# Grimes Planning and Zoning Commission

## **Planning and Zoning Commission September 22, 2022 In Person at Grimes Community Complex, 410 SE Main Street, Room 202**

TO: Planning and Zoning Commission  
FROM: Molly Mannel, Assistant Planner  
DATE: September 6, 2022  
RE: Rock Creek Plat 1 – Preliminary Plat

TO: Planning and Zoning Commission  
FROM: Molly Mannel, Assistant Planner  
DATE: September 6, 2022  
RE: Rock Creek Building 1 – Site Plan

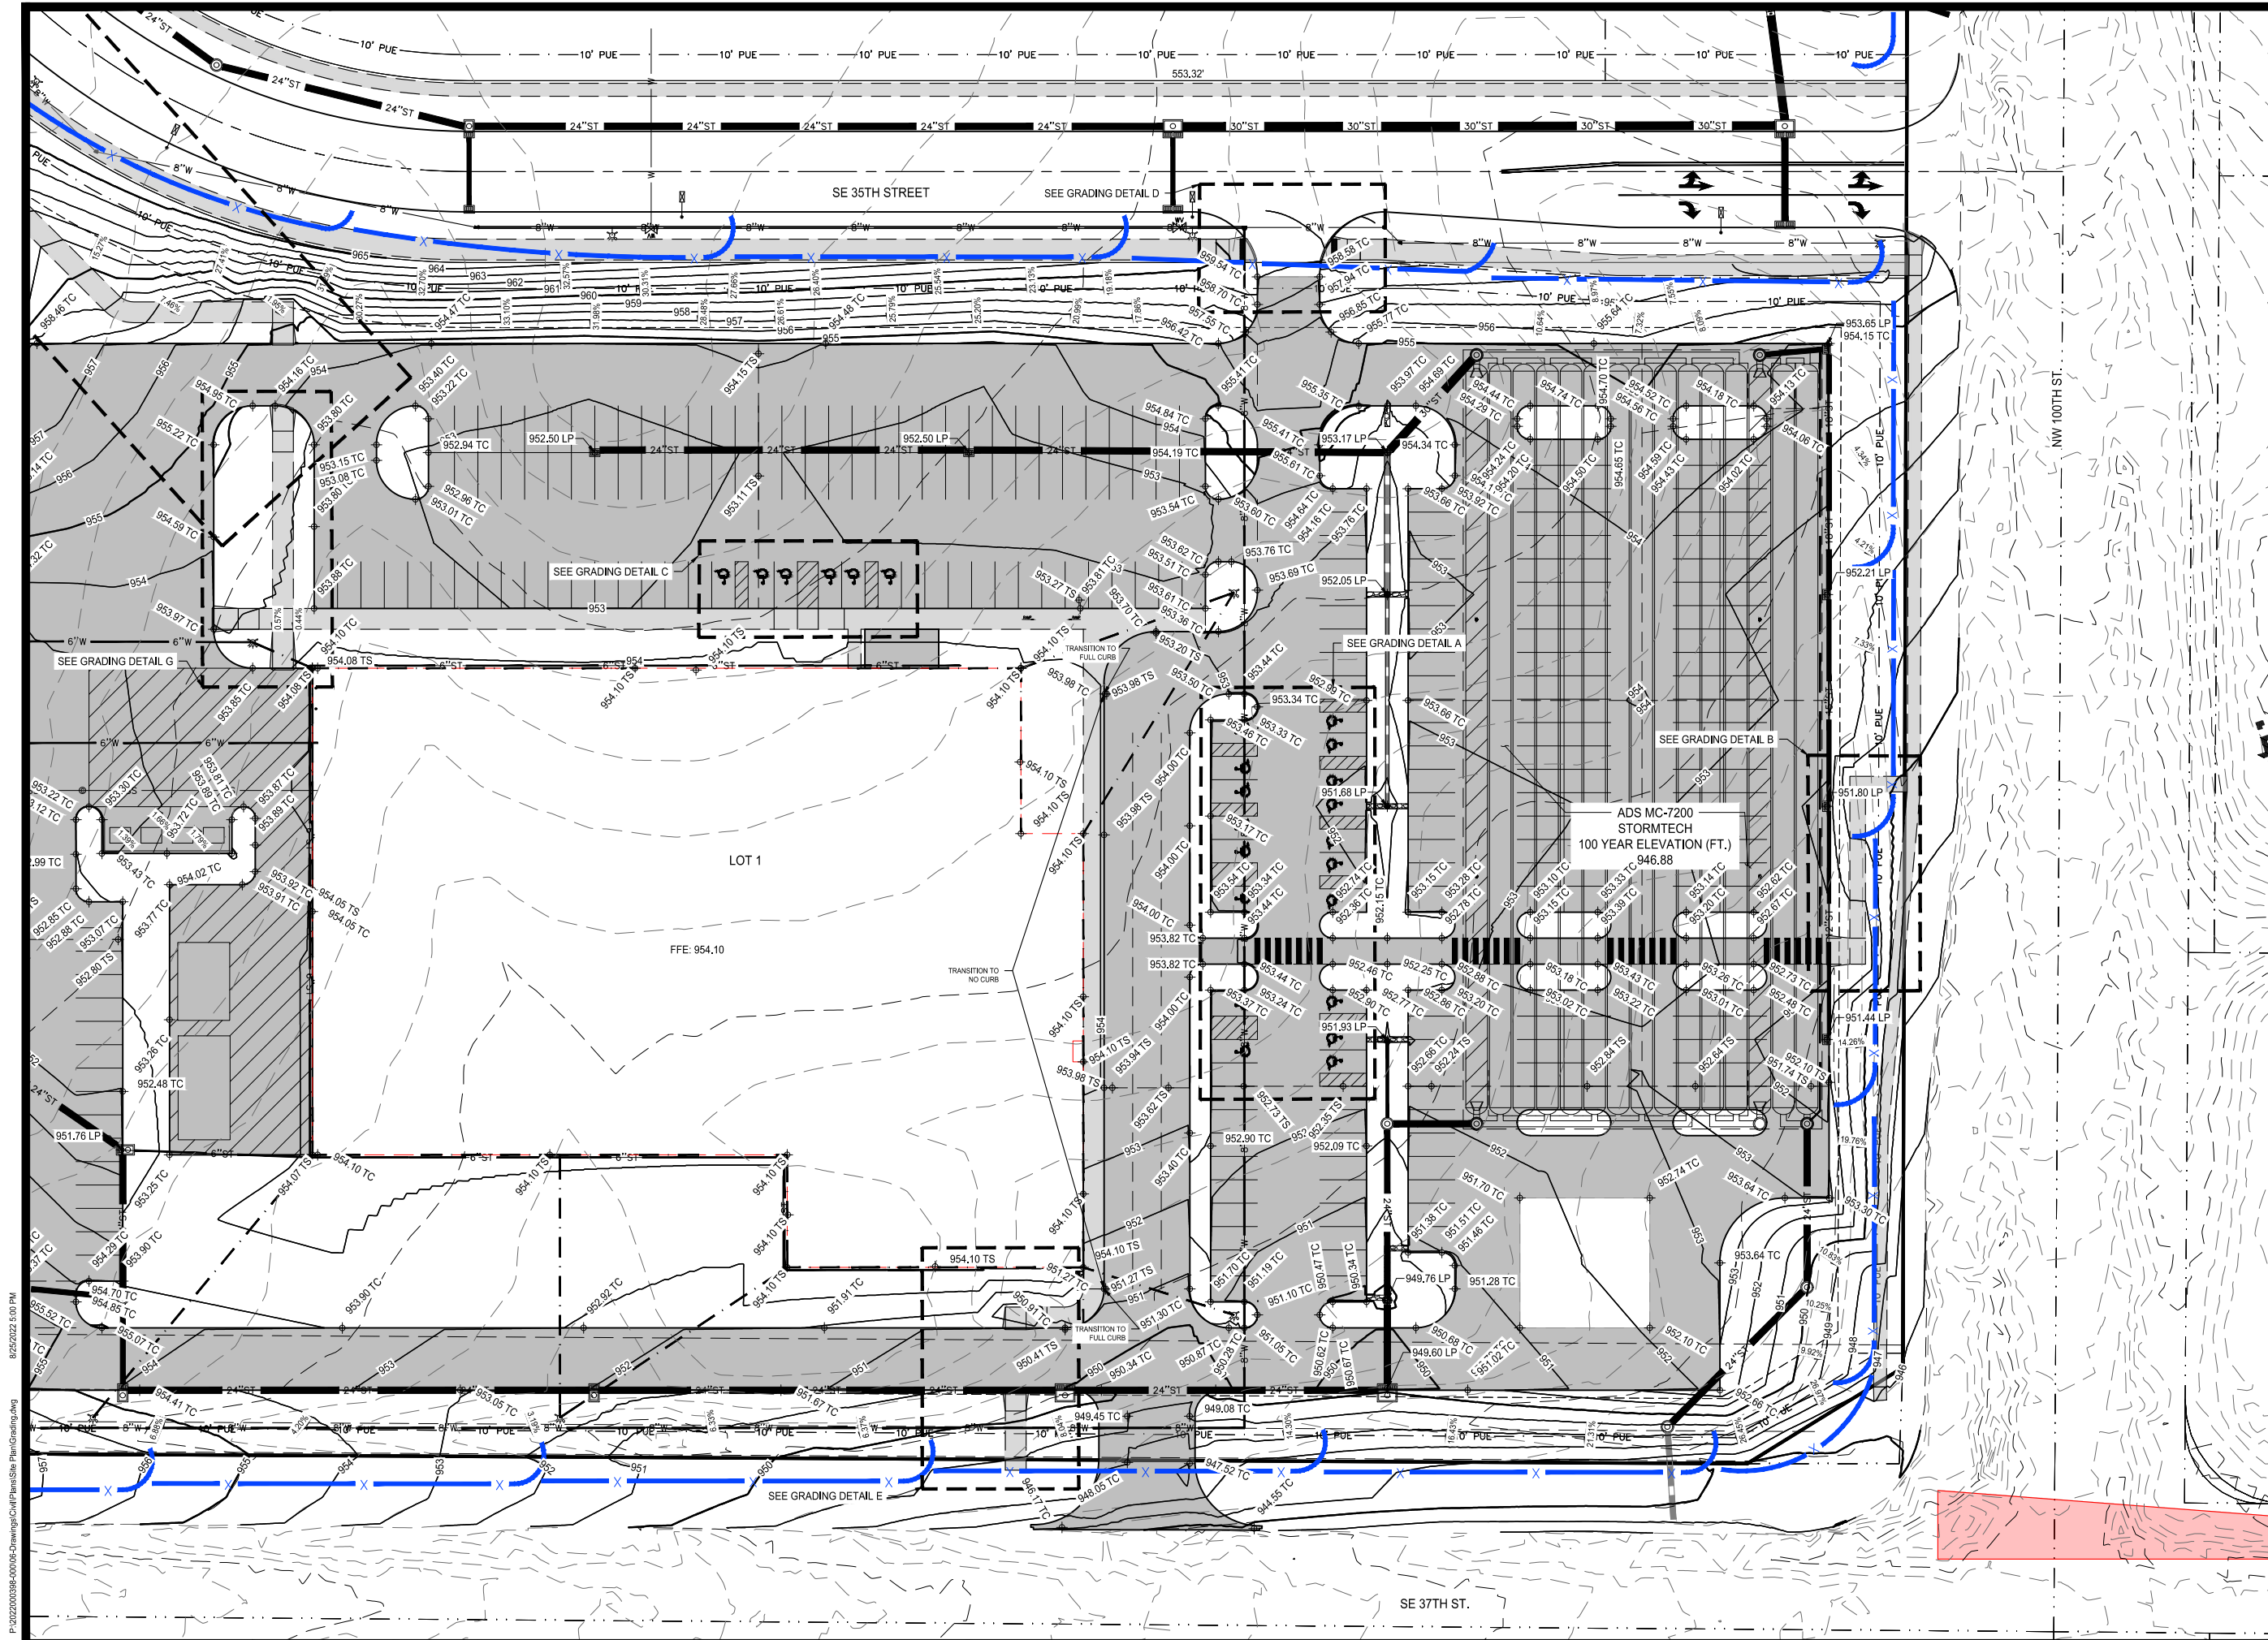
- ~~1. Add pavement hatch for better clarity.~~
- ~~2. Please provide more proposed contour labels. Please label contours.~~
- ~~3. Provide spot elevations at all low points. Add spot elevations and slope labels.~~
- ~~4. Label Finish floor elevation.~~
- ~~5. Please fix overlapping labels.~~

6. Verify slope on the north side of the site from the ROW to the parking lot. 4:1 preferred, 3:1 allowed. Please provide a minimum 2-foot safety shelf on the building side of the sidewalk.
7. Grading does not show a sump condition at intakes 104 and 104A. Provide a sump to capture the 100-year storm event.
8. How will the sidewalks tie into the pavement? Label spot elevations. Are ramps required? If so, provide ramps details.

A-202

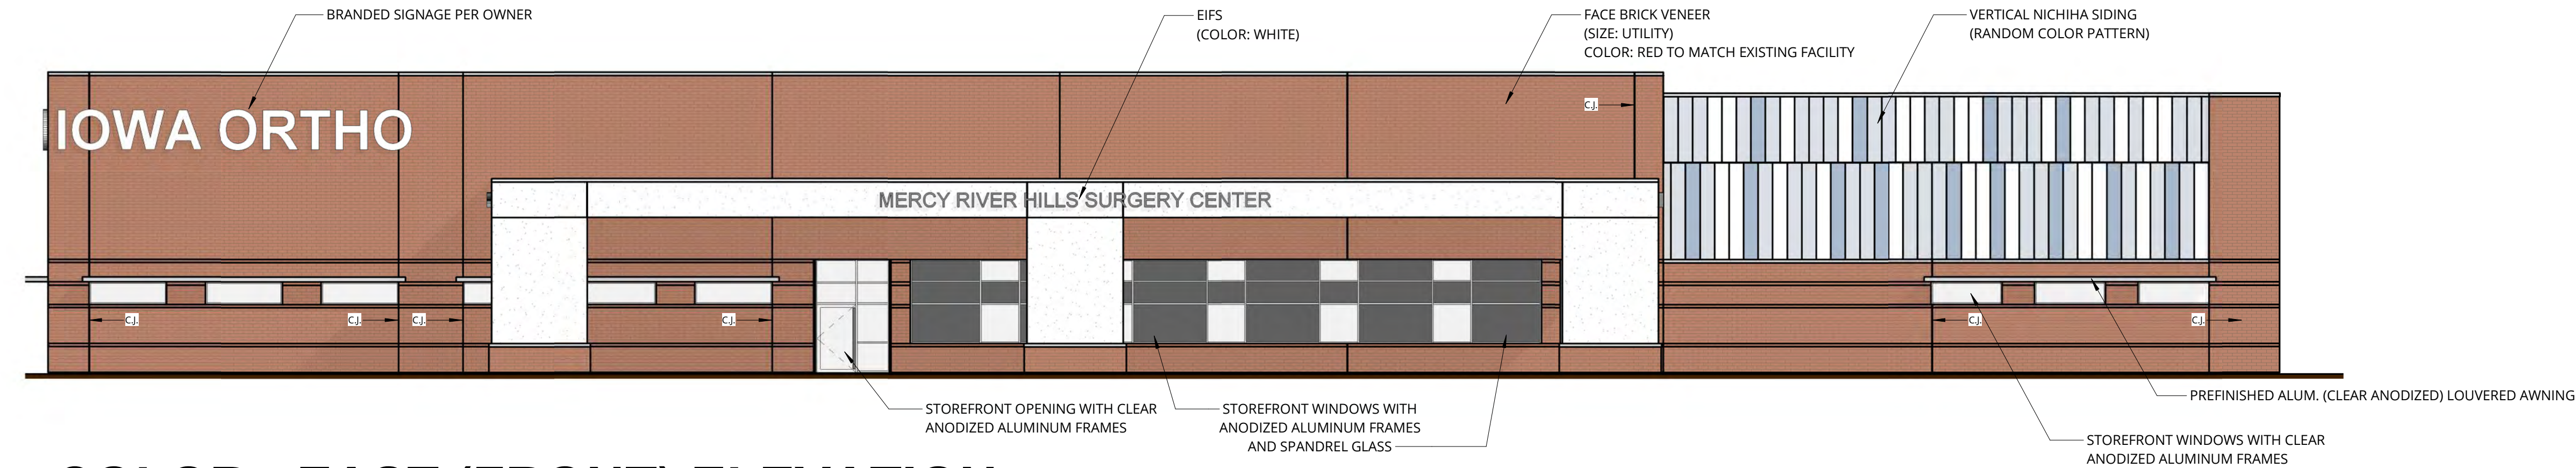
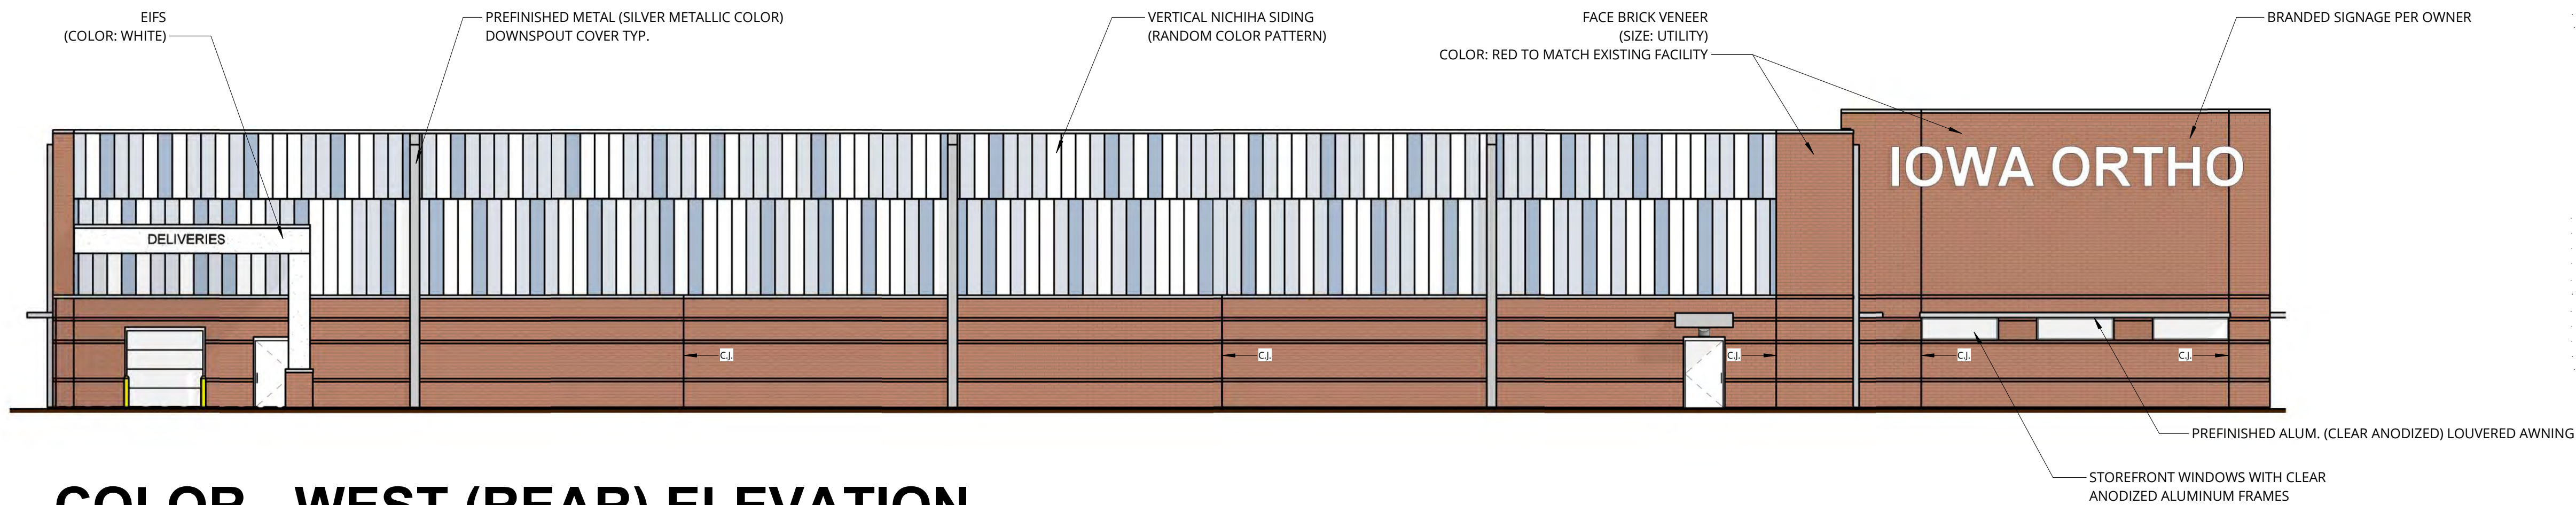
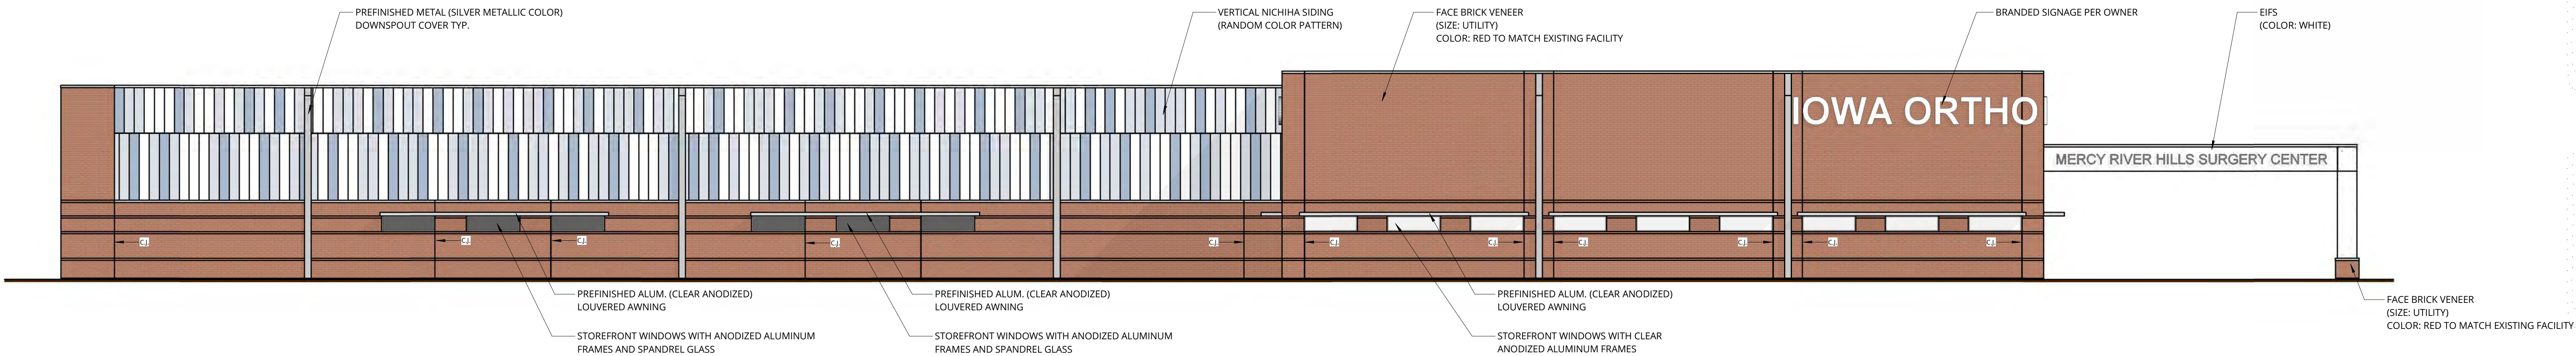
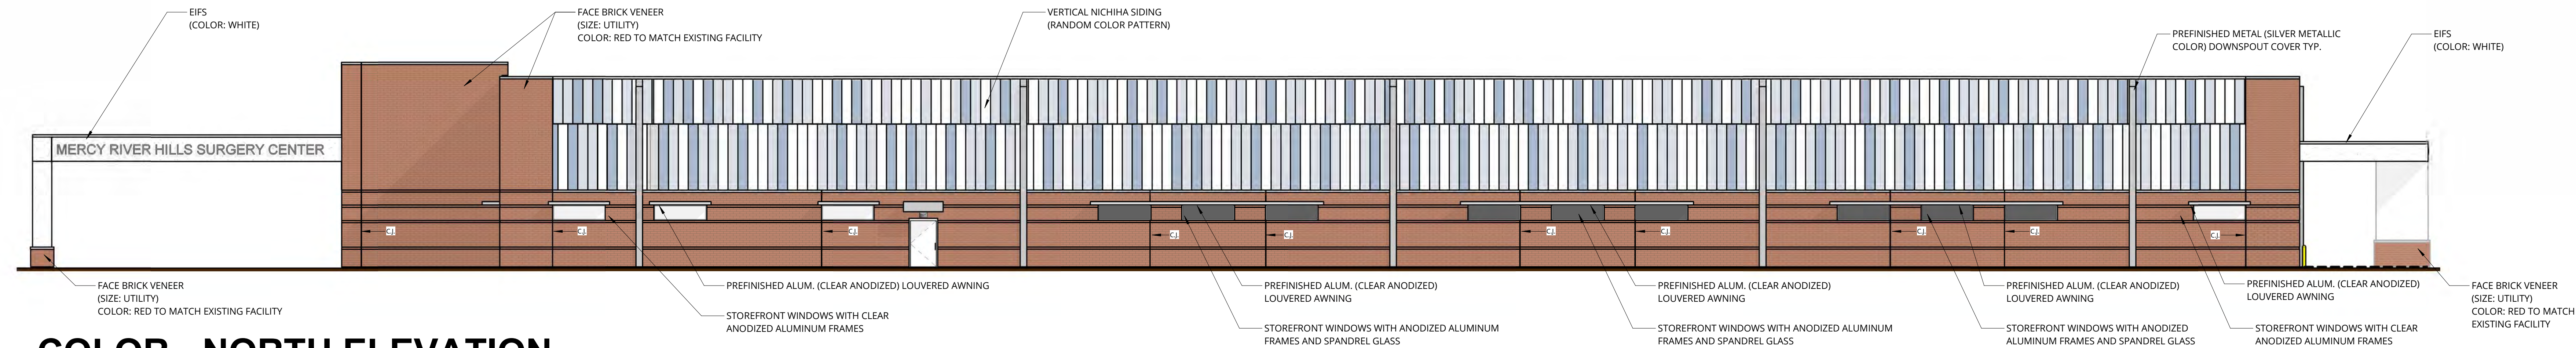
7. Provide generator/chiller screening elevations. Please provide.
8. On the NW corner of the building, please extend brick up to the parapet and then extend roof line up to provide more roof articulation. This will enhance the corner and break up the plane of niches. Staff prefers this – architect has made note via Zoom discussion.
9. ~~Is this pattern the pattern you are going to build? We expect the elevation to match the final construction.~~
10. Staff questions how the 40% of the building façade length along the ROW is being met. Please ensure 40% of the building length is glazing.
11. ~~Based on the material provided, a 4/5 vote of approval is required by council.~~
